**Attachment 1**  
**Preliminary Design Drawings (Excerpt)**

**3666, 3672, & 3682 Mt. Diablo Boulevard, Lafayette, CA**  
Planning Re-Submittal, October 24, 2014

**Attachment 2**  
**Transportation Impact Study (Excerpt)**

Date: September 23, 2014  
To: Chad Kiltz, Lennar Corporation  
From: Dan Hennessey and Ellen Poling, Fehr & Peers  
Subject: **Lafayette Residential Development Transportation Impact Study**

Figure 9  
Site Plan Recommendations

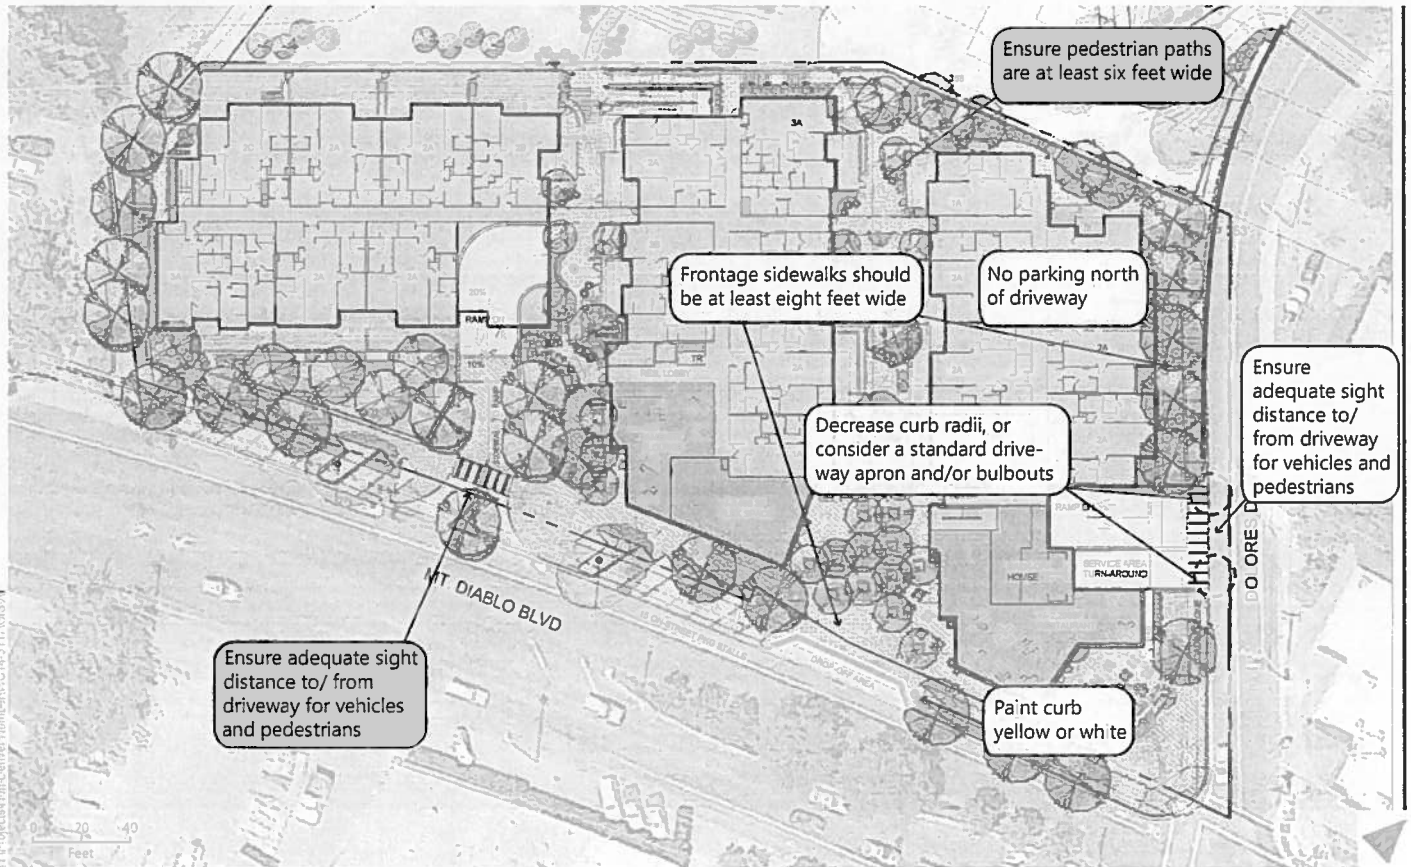
The Project site plan has been reviewed with consideration for safe and efficient circulation of motor vehicles, bicyclists, and pedestrians through the Project site and on the roadways adjacent to the Project site. **Figure 9** shows the site plan that was reviewed for this study, which is current as of September 22, 2014. The review focuses on:

Figure 10  
 Driveway Sight Distances

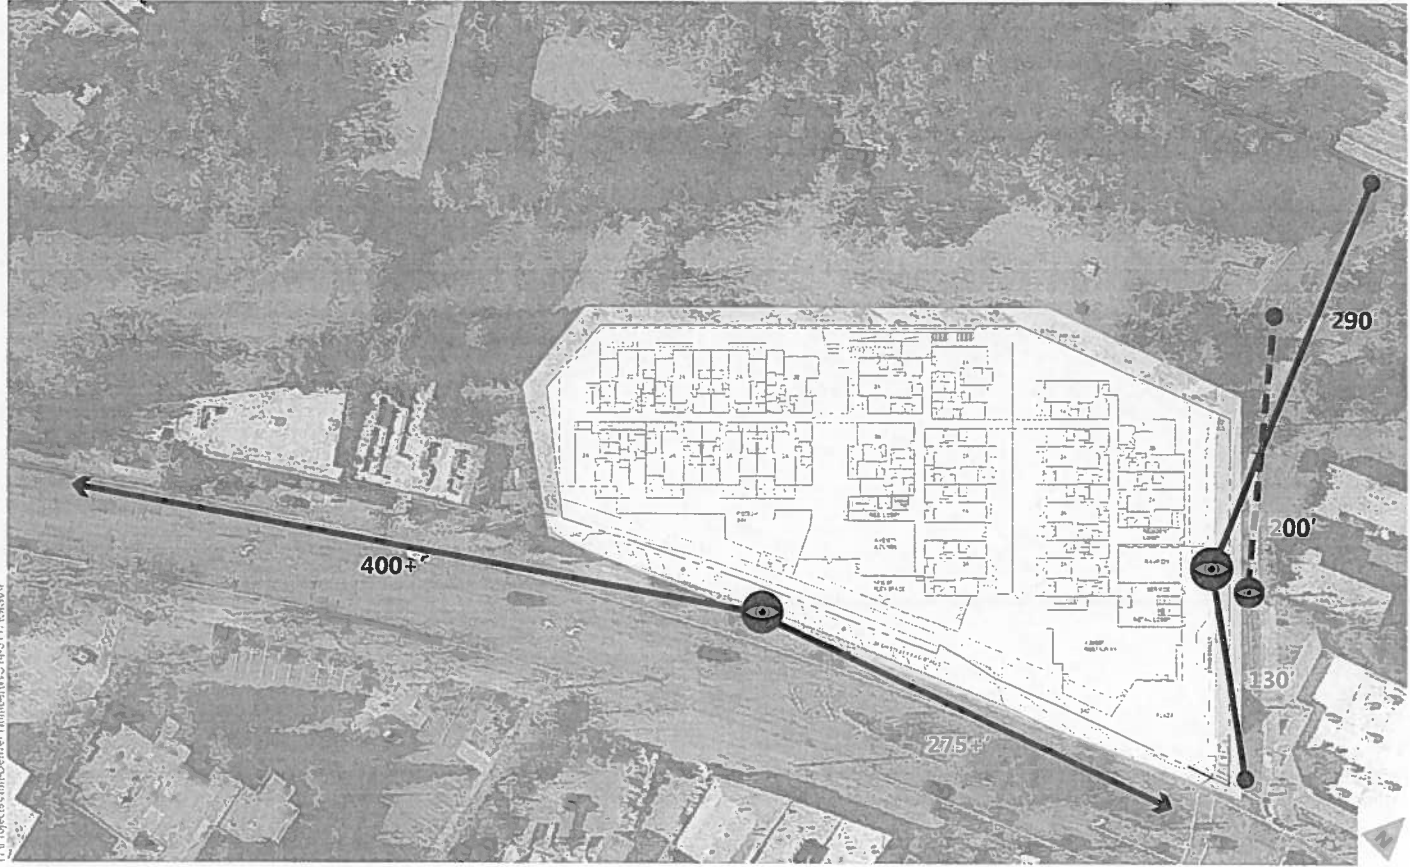
Due to the curvature of the road, vehicles turning left into the Project driveway would have approximately 200 feet of sight distance to see southbound vehicles on Dolores Drive. **Figure 10** shows the sight distances at each driveway. As shown, the proposed driveway layout provides adequate sight distance in each direction. Additionally, the proposed loading driveway adjacent to the south edge of the proposed access driveway will have approximately the same sight distance to the north. The service area appears long enough that trucks in the loading dock should not obscure the view of drivers attempting to exit the driveway and turn north onto Dolores Drive. Trucks should be able to efficiently maneuver into the loading space, though use of the loading dock should be limited to outside the morning and afternoon peak periods given its proximity to Mount Diablo Boulevard.

With the proposed on-street angled parking, the project's driveway will be between two on-street parking zones. This will also be a potentially busy pedestrian area, increasing the importance of appropriate sight distance at this location. The proposed plan will allow drivers exiting the Project to first cross the sidewalk before entering the storage space between the Mount Diablo Boulevard travel lane and the sidewalk. This space can be utilized to determine if there is an acceptable gap for vehicles to enter Mount Diablo Boulevard. Sidewalk extensions or "bulb-outs" could also be considered at the driveway to increase vehicle sight distance near the parking areas, though it appears the on-street parking to the east is far enough to not obstruct sight distance from the driveway. The proposed design provides adequate sight distance in each direction, as shown on **Figure 10**.
